Petition Number: #2022-105

Transportation Summary

Rezoning Transportation Analysis Petition Number: #2022-105 General Location Identifier: 05549113, 05549114, 05549115, 05549128

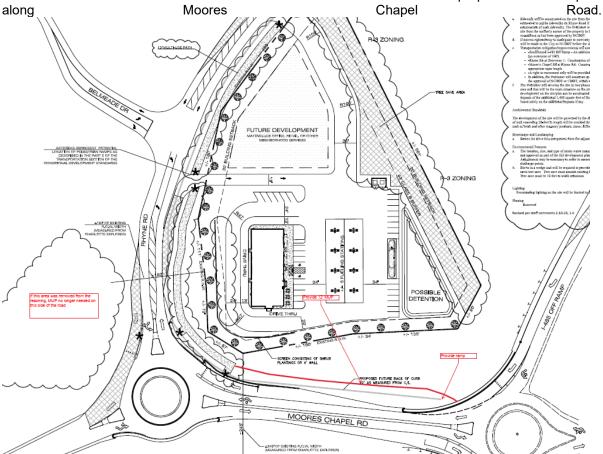
- 3. New Comment from 04/09/2024: Remove improvement below. This has already been constructed. Only improvement at Rhyne Road and Belmeade Road intersection should be what is circled below.

Bework

- Rhyne Rd at Belmeade Rd Construction of an eastbound left turn lane on Belmeade with 150' of storage plus
- Construct a soughbound right turn lane with 100' of storage on Rhyne Road.
